February 25, 2005

Re: **Comments and Objections to Application for Pre-Preliminary Plan, Plan No. 7-05036 (the "Pre-Preliminary Plan") for Clubbs Farm (Existing Parcel P860), Lots 1-3 (the "Development Parcel"), and Request to Board for Relief**

EXISTING TOPOGRAPHICAL MAP OF PIONEER HILLS SUBDIVISION

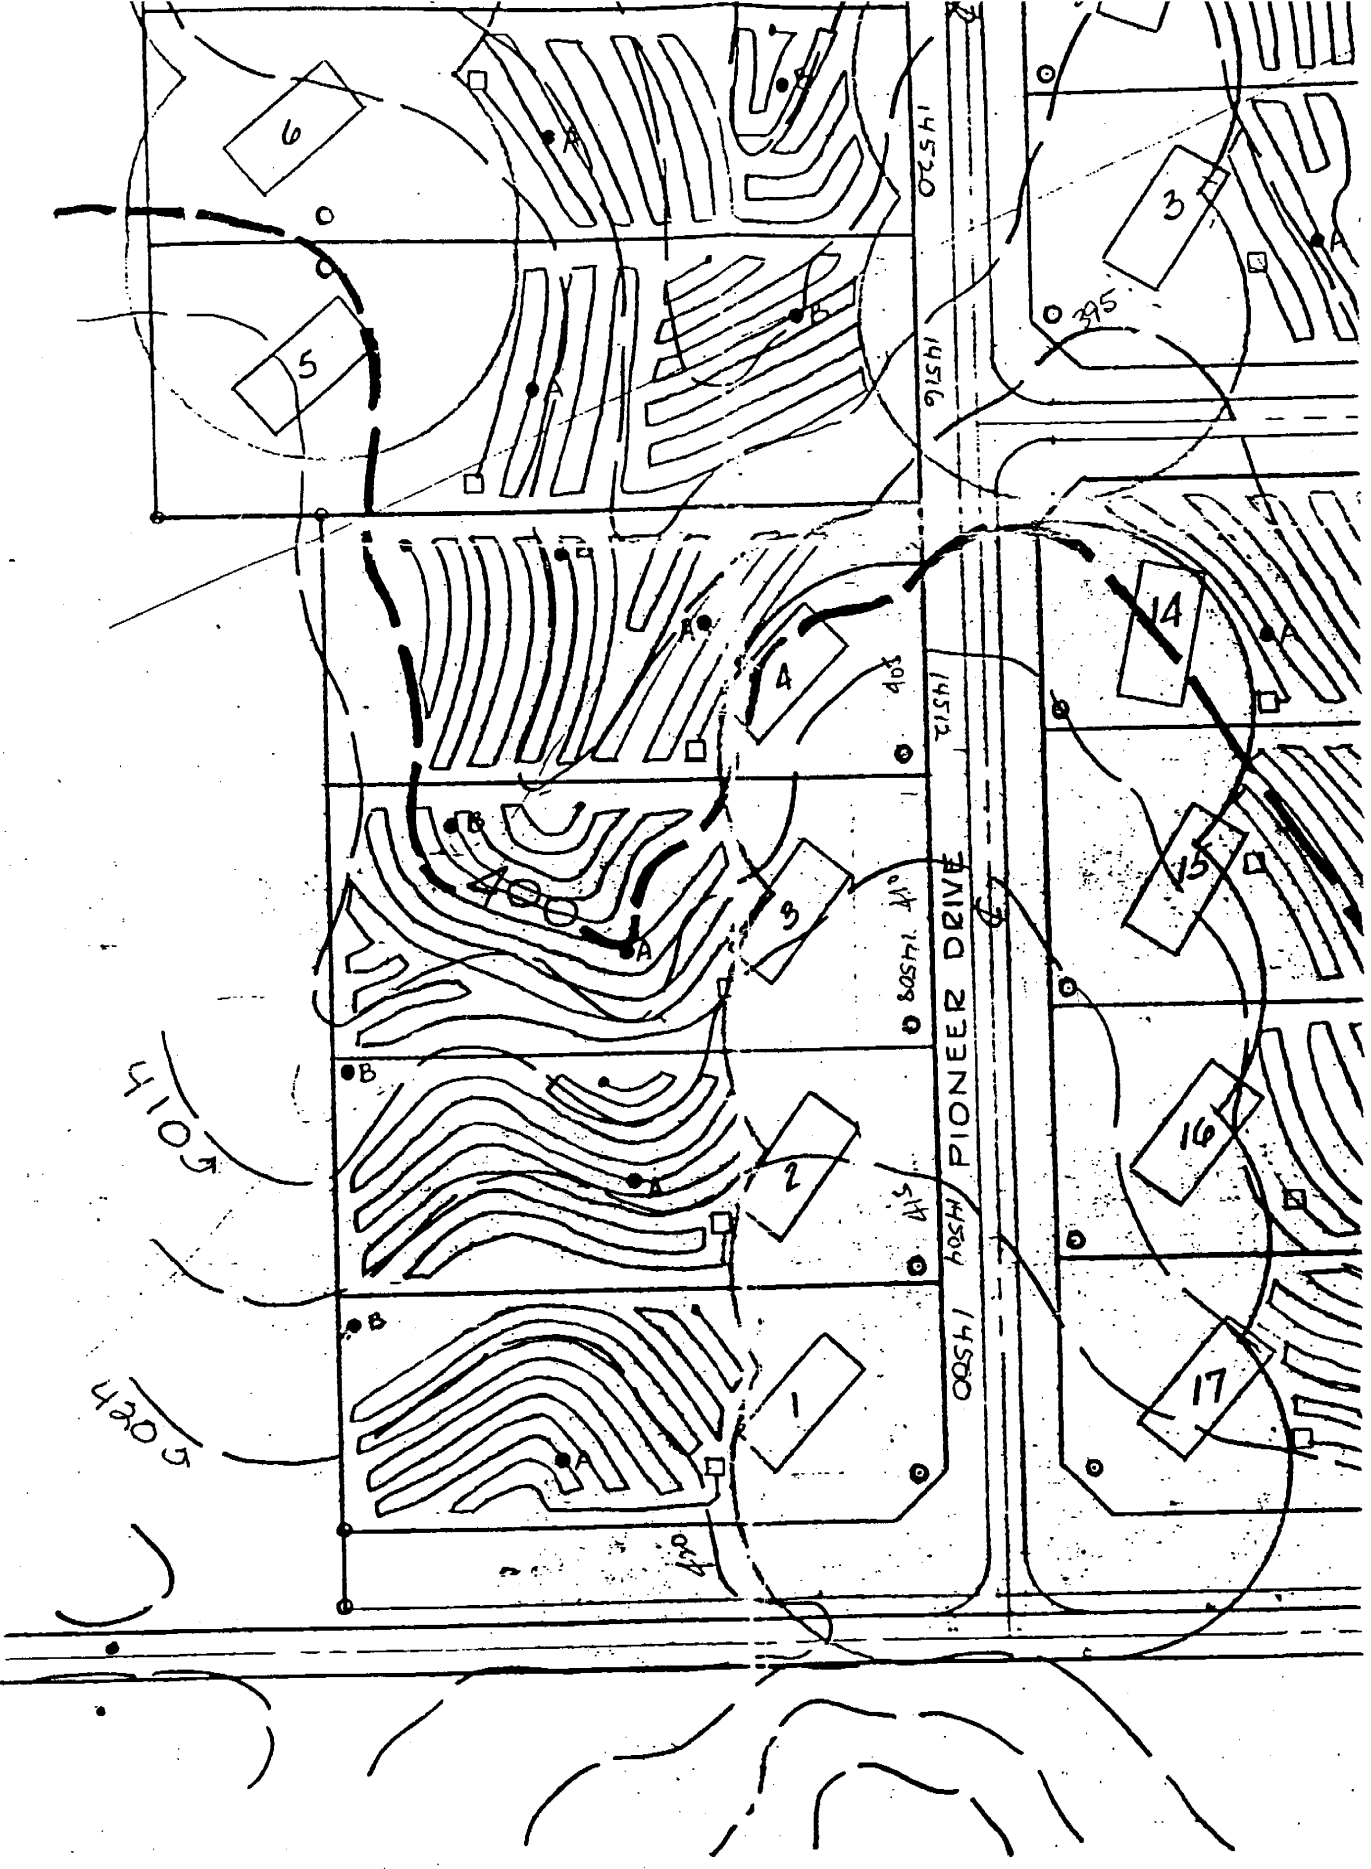
Objection 2. The Homeowners object to the topographical data provided in the Pre-Preliminary Plan. This topographical data is contrary to the topographical lines contained in the topographical map of the Pioneer Hills subdivision, a photocopy of which is attached as Exhibit B, and made a part of this letter. In fact, the topographical lines seem particularly inaccurate in the area where the septic drain field on Lot 1 of the Proposed Development ("**Proposed Lot 1**") is located, which has serious ramifications as discussed below.

The Homeowners' respectfully request that the Board and the Development Review Division (the "**DRD**") require the applicant to revise the Pre-Preliminary Plan to accurately show the topography of the Homeowners' land. Without this information, the Homeowners respectfully state that the Board and the DRD do not have sufficient information to determine the affect of the Proposed Development on the Homeowners.
